CHANGELOG:

v7 -> v8
- added second lowside resistor to achive 5R easier/cheaper (10||10)
- changed micro USB footprint to smd
- changed drills from 0.8mm to 0.9mm and 0.1mm offset per bank
- increased DS2431 footprint

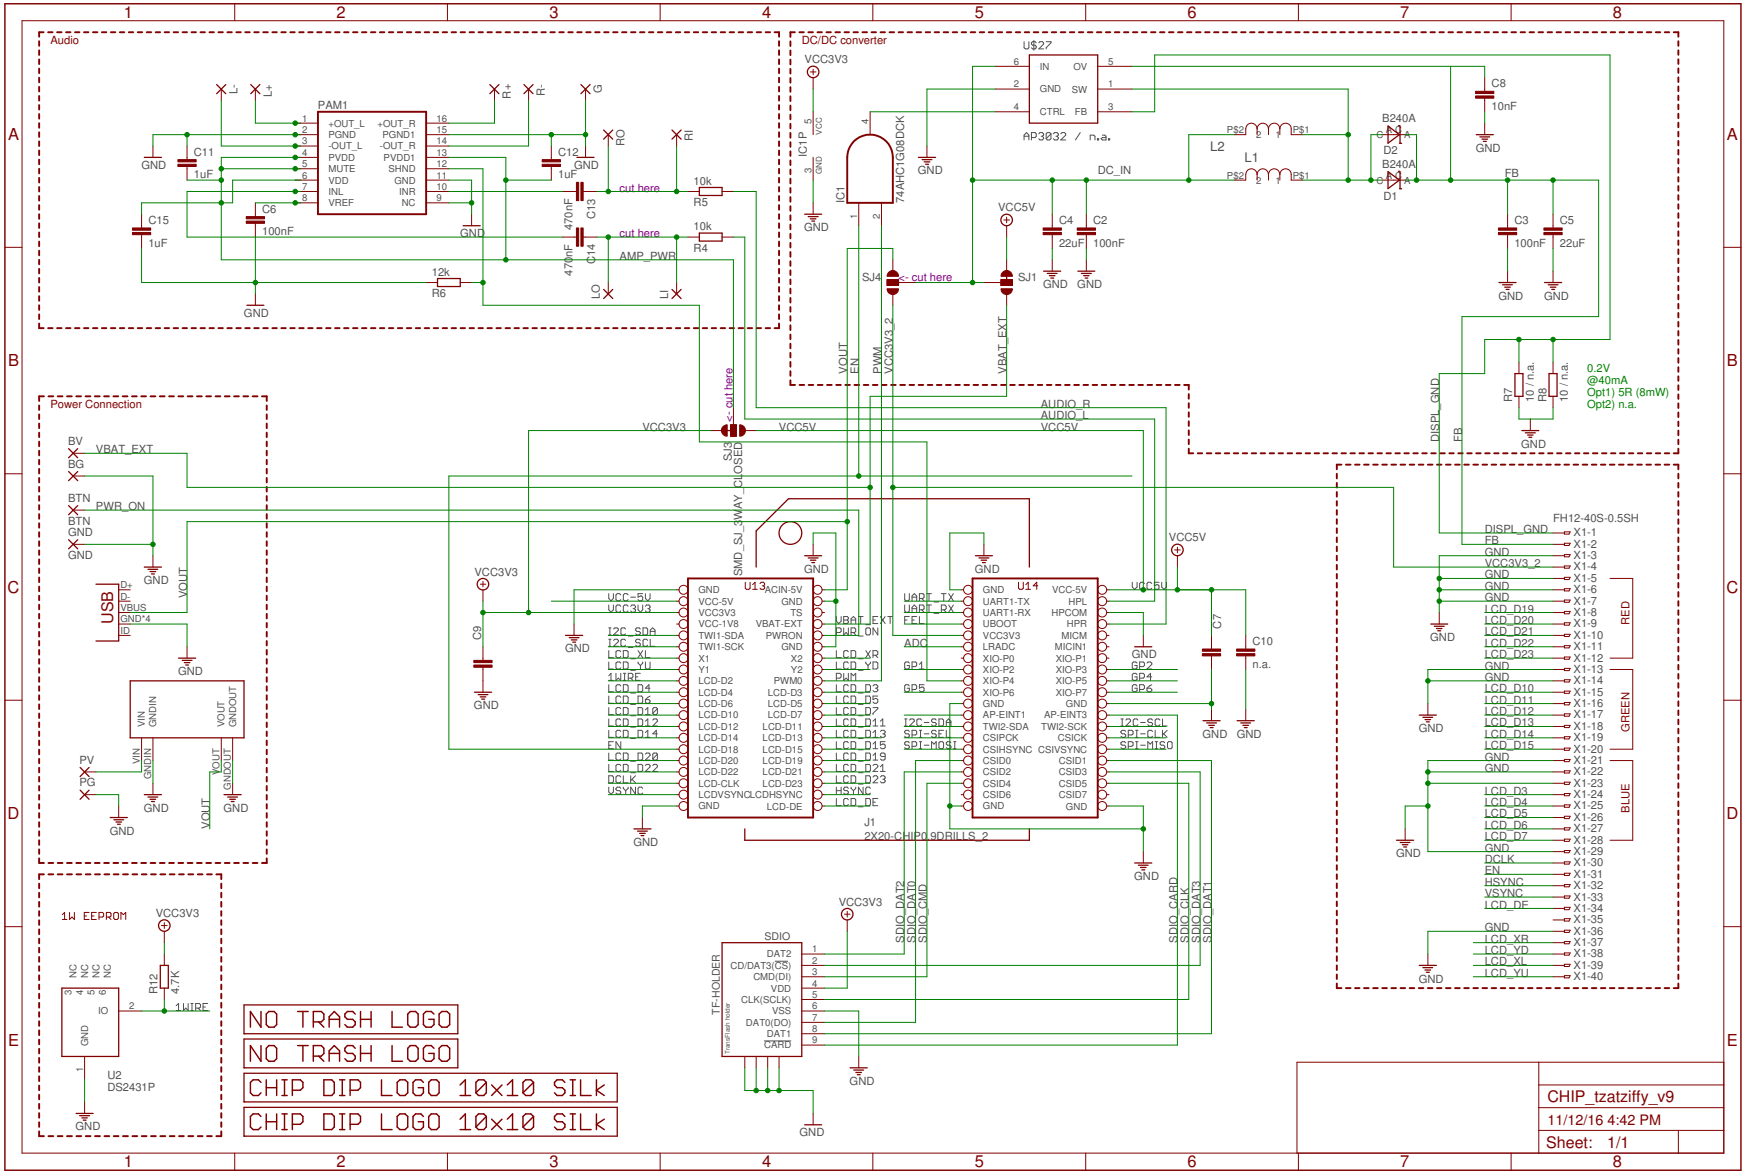
0.7mm is actually 0.7mm and too small for the pins

0.8mm is actually 0.85mm and too lose
